COUNCIL ASSESSMENT REPORT

HUNTER AND CENTRAL COAST REGIONAL PLANNING PANEL

PANEL REFERENCE & DA NUMBER	PPSHCC-160 – DA2022-01317 - PAN-280964
PROPOSAL	DA2022-01317 - Stage 2 involving demolition of existing structures and the erection of a mixed use development proposing 121 apartments, retail premises and associated parking, landscaping, services and associated two lot subdivision.
ADDRESS	Lot 1 DP 867617 - 711 Hunter Street Newcastle West
APPLICANT	Urbis Pty Ltd
OWNER	Hunter Street JV CO Pty Ltd
DA LODGEMENT DATE	17/11/2022
APPLICATION TYPE	Development Application
REGIONALLY SIGNIFICANT CRITERIA	Section 2.19(1) and Clause 2 of Schedule 6 of State Environmental Planning Policy (Planning Systems) 2021 declares the proposal regionally significant development as: Development that has a capital investment value of more than \$30 million.
CIV	\$65,382,029.00 (excluding GST)
CLAUSE 4.6 REQUESTS	<ul style="list-style-type: none"> • CI4.4 – Floor Space Ratio NLEP 2012 • CI7.4 – Building Separation NLEP 2012

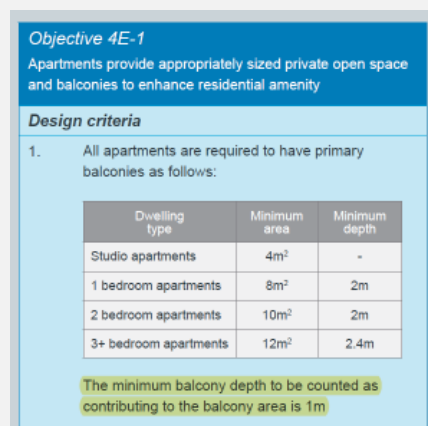
<p><i>The UDRP noted that the proportions (areas and widths) of the provided balconies fell short of ADG recommendations in a number of instances. While it is not acceptable that the Design Verification Statement states ADG compliance when this is not the case, the layouts of the balconies were evident on the plans, if not the areas. While falling short in some respects, given that the dimensions of the balconies was not raised as an issue during either review process, and that they are reasonably functional and useful as laid out, and considering that increasing balcony dimensions would require a major replanning of apartment interiors, it is not concluded appropriate that a further modification at this stage in the review process is warranted.</i></p> <p>Applicants Response</p> <p>Balcony Size</p> <p>The development is 100% compliant with minimum size – refer to detailed apartment breakdown.</p> <p>The ADG allows for balcony areas in excess of 1m to be included in the area calculation. The independent assessment only calculated balcony areas in excess of the 2m or 2.4m minimum dimension which is incompatible with the ADG definition.</p> <p>Balcony Dimension</p> <p>Stage 1: 99.3% compliant (135/136) refer to detailed apartment breakdown. One apartment being Apartment 1.25.03 (3-bed) is the only non-compliant balcony for Stage 1, however is significantly larger than minimum size requires to compensate and demonstrated to cater for a range of furniture layouts.</p> <p>Stage 2: 98% (120/122) refer to detailed apartment breakdown Compliant</p> <p>Apartments 2.25.01 (3 bed) and 2.25.03 (3 bed) are marginally non-compliant due to the irregular tower form. However, are significantly larger than minimum size requires to compensate and demonstrated to cater for a range of furniture layouts.</p>

The revised plans and documentation has been considered at a third meeting by CN's UDRP which provided the following comments in respect to balconies (as included at **Attachment B**): -

Noted that ADG includes an exception that allows lesser widths over 1.0 metre wide to contribute to the balcony areas.

The areas/dimensions of the balconies are considered acceptable in terms of amenity and outcomes on merit.

Figure 1 - Movable all weather protection of floor refuge

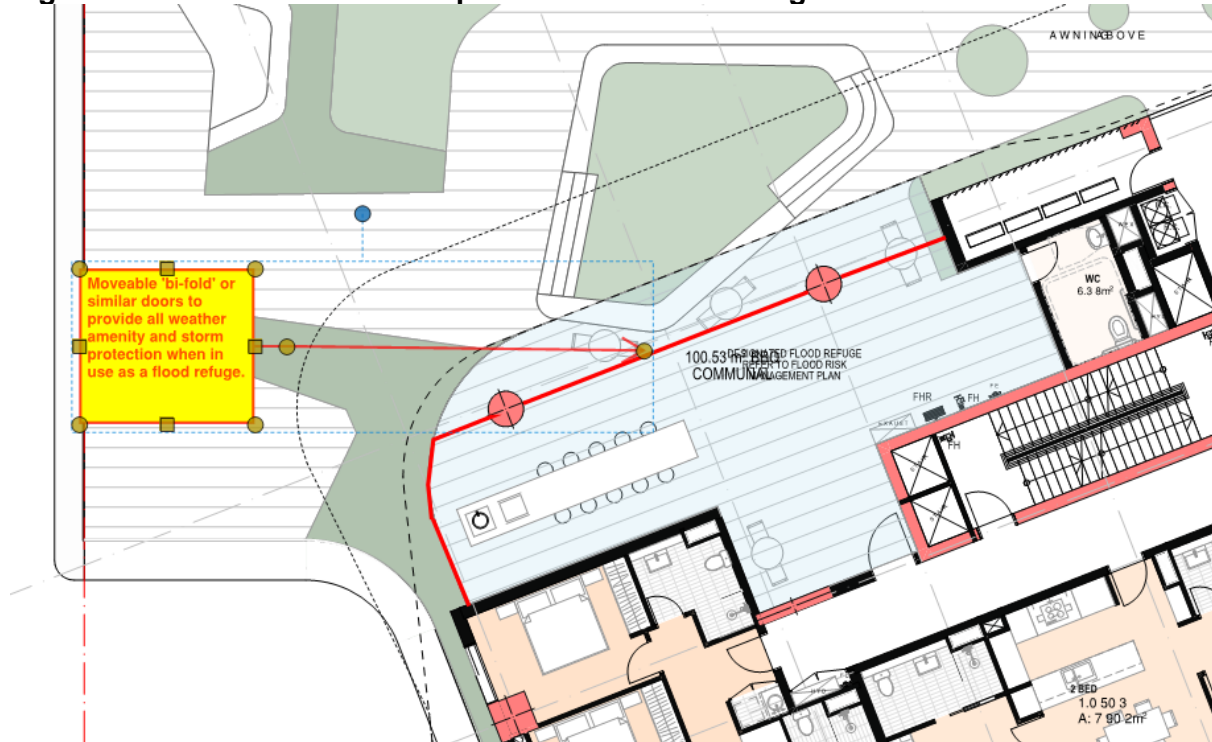
The proposed flood refuge is proposed within the Stage 1 tower and is considered to have sufficient area for its purpose as it only needs to be available for staff and customers of the ground floor retail premises. The flood refuge is not fully weather enclosed as proposed. It is considered that when the use of the flood refuge is necessary, this would typically be a significant storm event. To address this issue it is recommended that a condition of consent be imposed (as included at **Attachment A**) that the area be provided with 'bi-fold' style doors or similar that have a high architectural quality (see **Figure 1** below) such that the area could be enclosed on a temporary basis. This would additionally allow the area to be enclosed to provide all weather amenity for the future residents of the development.

Overall, the proposed flood refuge is considered to be acceptable subject to conditions of consent.
